BRUNSWICK STEAM ELECTRIC PLANT, UNIT NO. 1  
DOCKET NO. 50-325/LICENSE NO. DPR-71  
SUPPLEMENT TO REQUEST FOR LICENSE AMENDMENT (TSC 00TSC06)  
INSERTION SURVEILLANCE OF CONTROL ROD 26-47  
RESPONSE TO REQUEST FOR ADDITIONAL INFORMATION

BRUNSWICK STEAM ELECTRIC PLANT, UNIT NO. 1  
DOCKET NO. 50-325/LICENSE NO. DPR-71  
SUPPLEMENT TO REQUEST FOR LICENSE AMENDMENT  
INSERTION SURVEILLANCE OF CONTROL ROD 26-47

### RESPONSE TO REQUEST FOR ADDITIONAL INFORMATION

**Figure 2**  
**Control Rod Drive Mechanism (Insert Mode)**

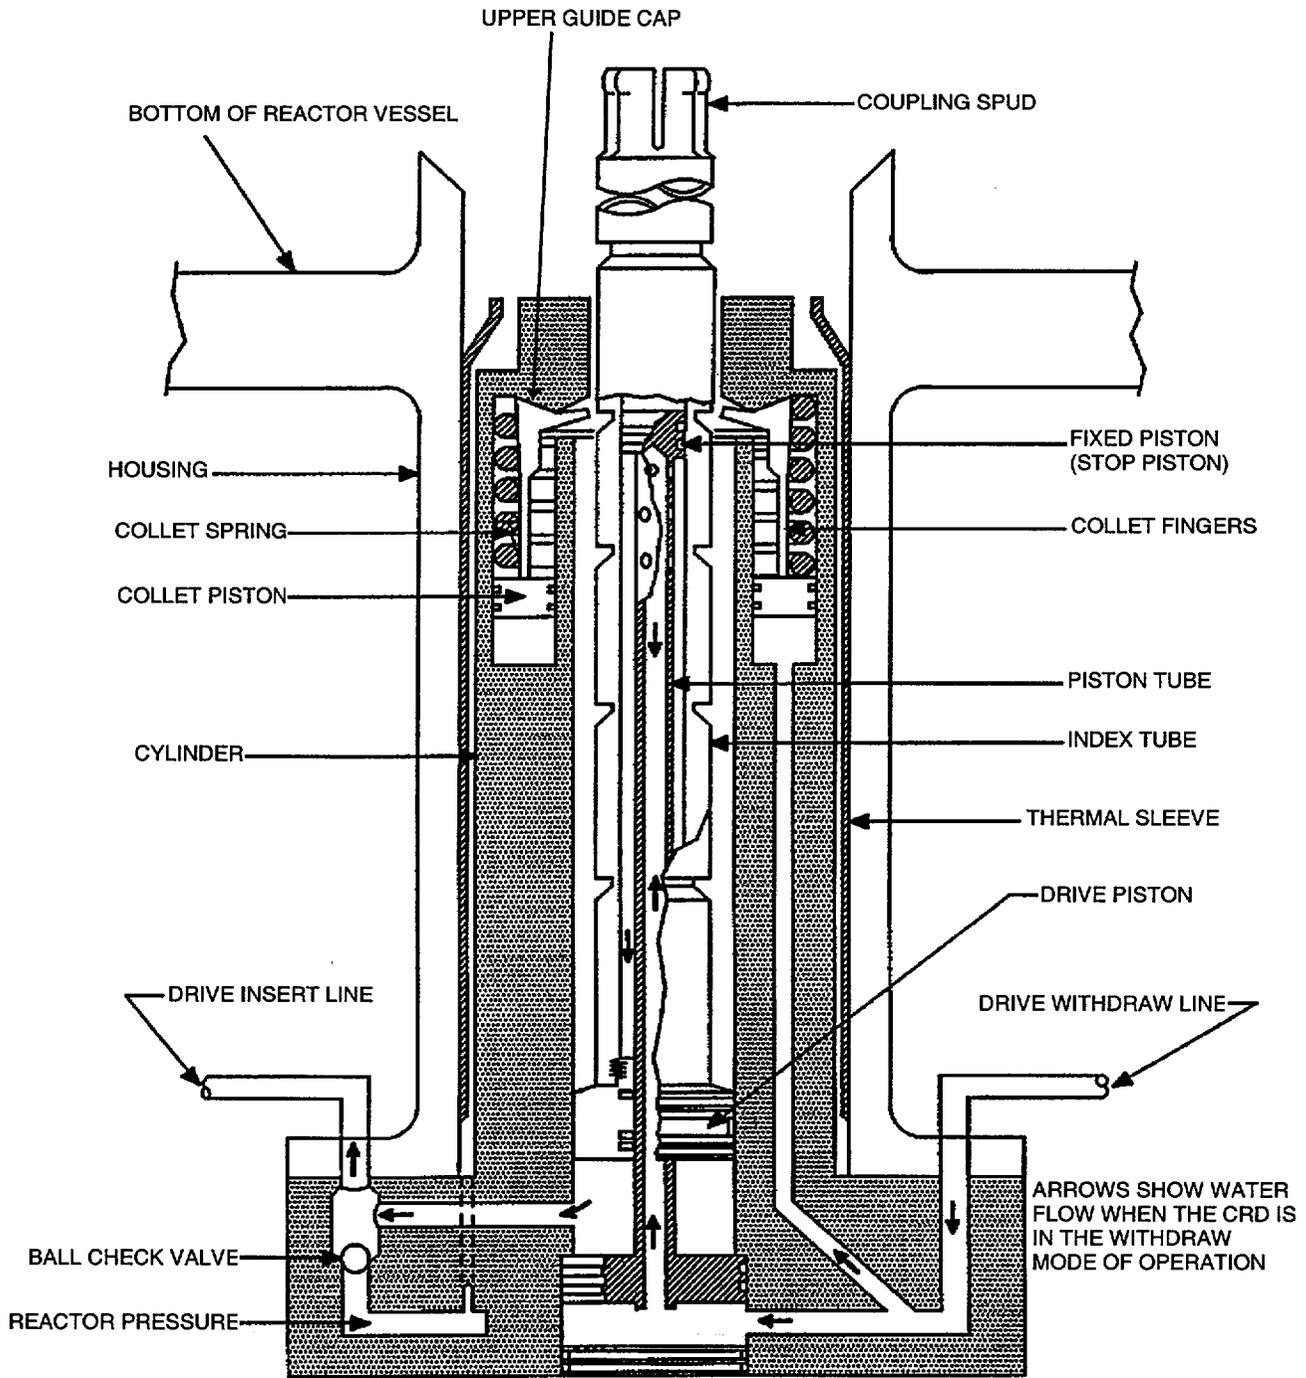
Please provide additional information supporting the conclusion that control rod 26-47 remains capable of inserting.

Due to the tapered design of the index tube notches, the collet piston mechanism will not impede rod insertion. When inserting, the tapered index tube slips through the six collet fingers. To insert a control rod under normal conditions (i.e., see Figure 2), water from the Control Rod

Drive Hydraulic System drive water header enters via the drive insert line providing motive force below the main drive piston. At the same time, water from the drive is discharged to the exhaust water header via the drive withdraw line. Water flow is directed between the index tube and piston tube, through the buffer holes, down between the piston tube and indicator tube, and out through the withdraw line.

As described above, control rod insertion, either manually or automatically, does not require the CRDM to actively control the position of the collet fingers, as is the case with control rod withdraw. Rather, the tapered design of the index tube allows it to slip through the six collet fingers on an insert or scram signal.
